**MACQUARIE POINT PLANNING PERMIT BILL 2025 – ENABLING LEGISLATION
SUBMISSION**

MACQUARIE POINT PLANNING PERMIT BILL 2025

City of Hobart Submission

Figure 2. Stepped boundary issues between MPDC & TasPorts

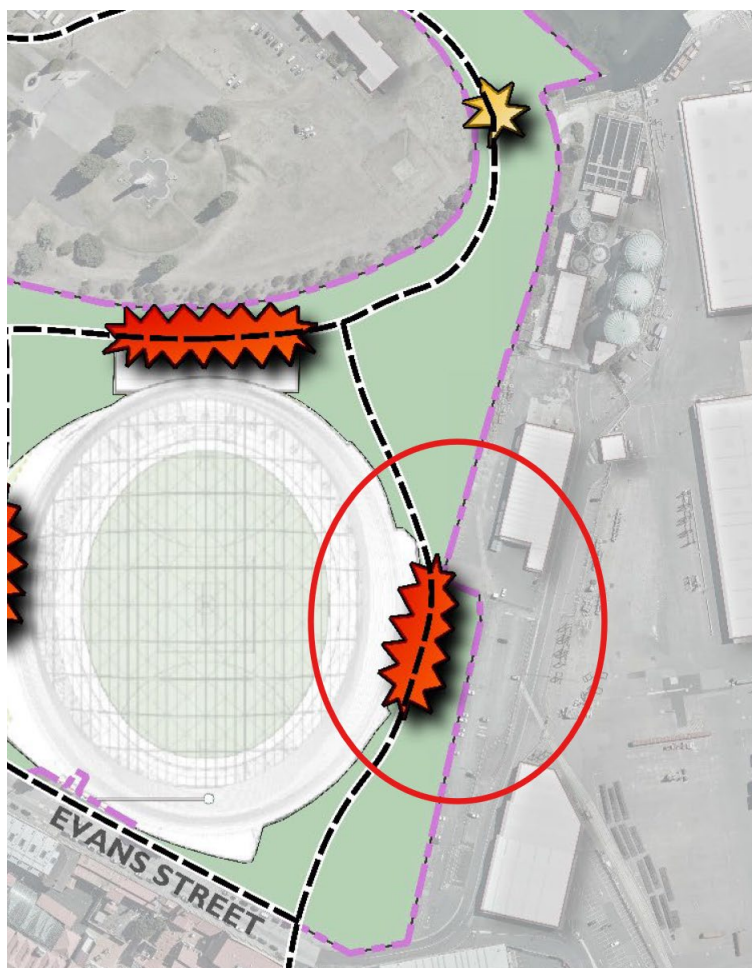
(j) The City agrees with the Panel that in order to improve functionality and safety of the proposed stadium design, additional dedicated space around the stadium building should be sort. The City implores the proponent and TasPorts to consider adjusting the eastern stepped boundary (as shown on Figure 2 below) as a matter of priority to allow for the full realisation of the Complementary Integrated Mixed Use Zone and Antarctic Facilities Zone as originally envisaged which will also go some way to alleviate some of the many pinch points identified around the precinct.
